**From:** "JAMAR, Brandon" <btj@nei.org>  
**To:** "Charles Moulton" <CEM4@nrc.gov>, "Sunil Weerakkody" <SDW1@nrc.gov>, <RHG@nrc.gov>  
**Date:** Mon, Jun 4, 2007 8:34 PM  
**Subject:** FAQ 06-0017 Rev. 2 for submittal

FAQ Title Ignition Source Counting Guidance for High Energy Arching Faults

**FAQ Number** 06-0012 Revision 4  
**FAQ Title** Determining Manual Actions that Require a Change Evaluation during Transition

**Attachment to FAQ 06-0012 Revision 4  
Excerpt from NEI 04-02 Revision 1 with Changes Tracked**

**Figure B-4 General Process to Transition Operator Manual Actions**

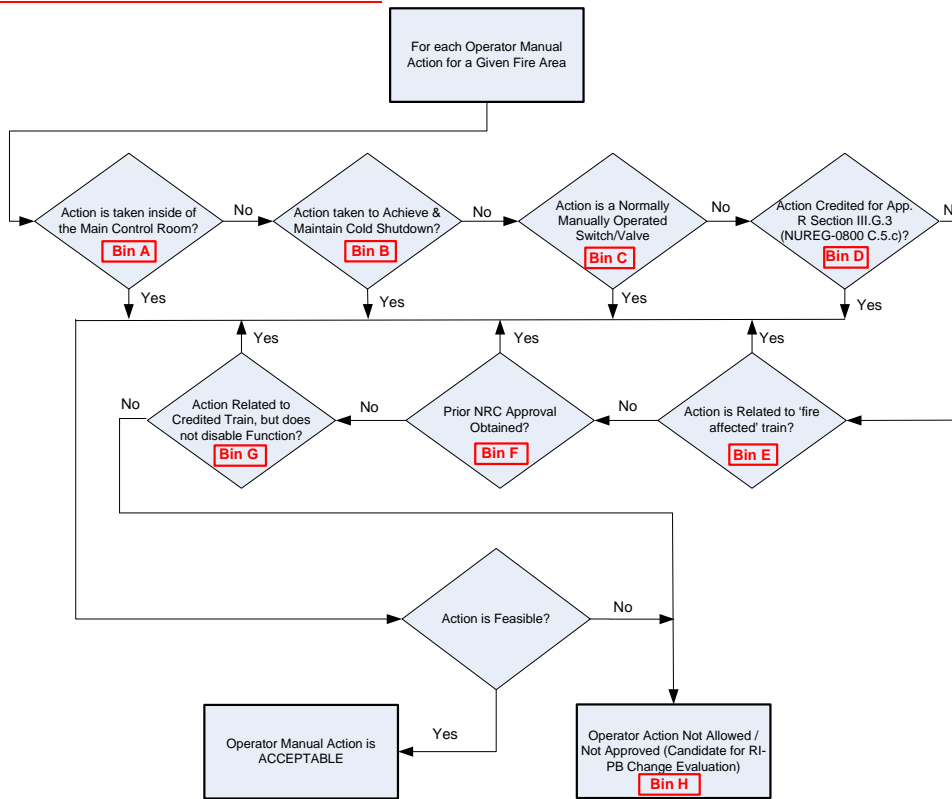
Figure B-4 depicts this general process for determining whether a transitioning operator manual action to NFPA 805 recovery action requires a change evaluation. The ‘bin’ identifiers are for ease of reference.

**Figure B-6 Allowed Operator Manual Action in Fire Area Meeting 10 CFR 50, Appendix R, Section III.G.2 Compliant – Operator Manual Action for Fire Affected Train**

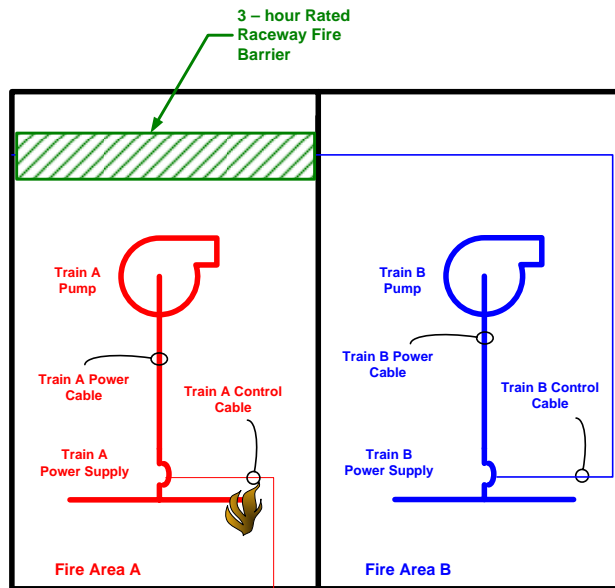
- Operation of fire affected equipment for fire areas that meet the protection requirements of Section III.G.2 of 10 CFR 50, Appendix R (or applicable sections of NUREG-0800) for redundant trains. See Figure B-6. [Bin E]

Fire Area B meets the separation criteria of 10 CFR 50 Appendix R Section III.G.2.a. A postulated fire in Fire Area A could result in the spurious starting of the non-credited Train A pump, which can be mitigated by an operator manual action to de-energize the Train A Power Supply to stop Pump A. This is functionally equivalent to Case in Figure B-5.

Figure B-7. Allowed Operator Manual Action – In Credited Success Path – Common Tank Suction

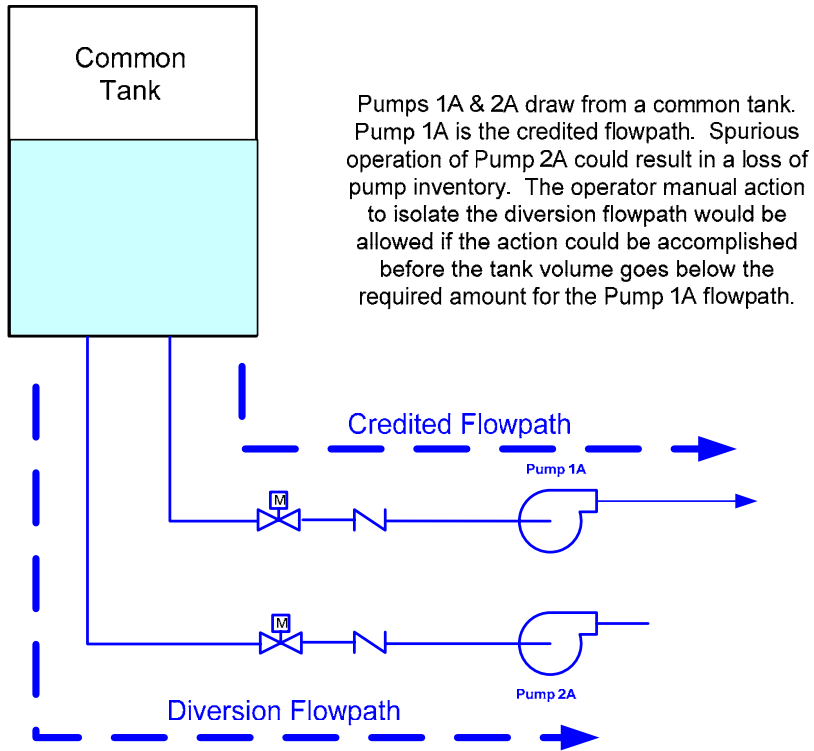
During the June 9, 2006 public meeting the following example was specifically discussed: Two redundant trains taking suction from a common tank. Provided the manual action can be accomplished prior to the tank volume going below the minimum required volume to support the credited function the action would be allowed and therefore not require a change evaluation. (Figure B-7)

Figure B-8, Allowed Operator Manual Action – In Credited Success Path – Auxiliary Feedwater Flow Diversion

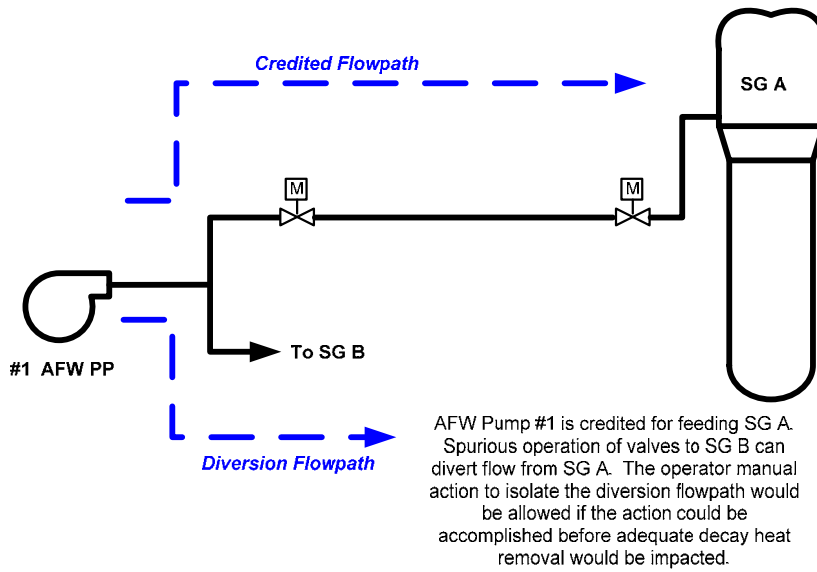
A second example is the credited function is to inject water to the Steam Generator (reactor) and a spurious actuation causes a diversion from the credited flow path. Provided the minimum required injection flow can be maintained and the operator action can be accomplished prior to the function being disabled. (Figure B-8)
